**CONTINENTAL MOTORS® AIRCRAFT ENGINE
CRITICAL SERVICE BULLETIN**

**CATEGORY 2
CSB13-1B**

**Supersedes CSB13-1A
TECHNICAL PORTIONS
FAA APPROVED**

SUBJECT: Replacement of Part No. 640560 Set Screws
Installed on Part Nos. 642100-X (X=1 through
6 & 8), 646292-1, 646663-1 and R-642100-3,
4, 5 and 6 Fuel Pressure Regulators

Figure 1. Fuel Regulator Set Screw Installation

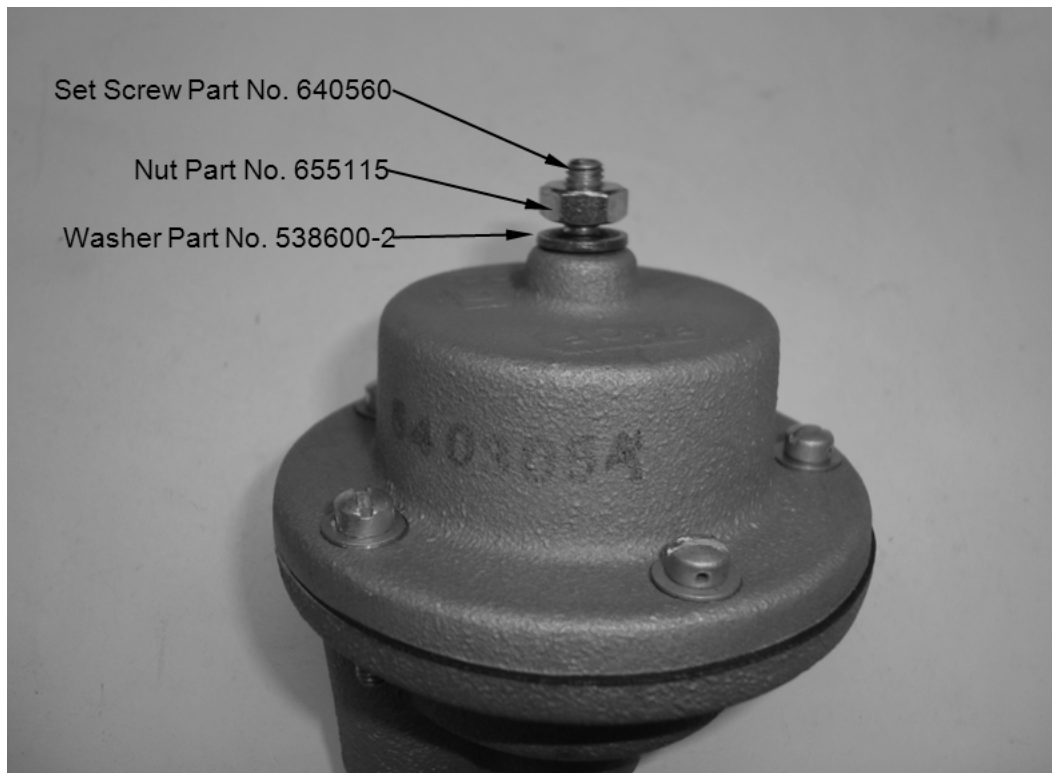
Continental Motors (CM) is issuing this bulletin to notify owners and/or operators of the requirement to replace certain part number 640560 Set Screws (Figure 1) in new part number 646663-1, 646292-1, and 642100-1, -2, -3, -4, -5, -6, -8 and rebuilt part number R-642100-3, -4, -5 and -6 fuel pressure regulators shipped from the factory between June 11, 2012 and February 26, 2013. It has been discovered during fuel system setup that some adjustment screws (Set Screws) on the fuel pressure regulators may exhibit hydrogen embrittlement, which may cause the Set Screw to fracture in service. Therefore: CM requires the replacement of all Set Screws installed on fuel pressure regulators and engines that were shipped from the factory between June 11, 2012 and February 26, 2013, within the next 10 hours of operation.

1. Contact the CM Service Department and order a new Set Screw (part number 640560), washer (part number 538600-2), and nut (part number 655115).
2. If the Set Screw is not fractured, note the adjustment of the Set Screw height (count exposed threads) to use as a reference for installation of the new Set Screw.

3. Using a 3/32” hex key (allen) wrench (or pliers if fractured), turn the Set Screw counter-clockwise to remove it from the regulator. Discard the old Set Screw (part number 640560), washer (part number 538600-2), and nut (part number 655115).

4. Install a new Set Screw (part number 640560), with washer (part number 538600-2), and nut (part number 655115).
5. Adjust the new Set Screw to the height noted in Step 2 of this paragraph, if applicable. Securely hold the Set Screw in the preliminary adjusted position and torque the jam nut to 21-25 inch-pounds. Use caution not to exceed the specified torque limit.
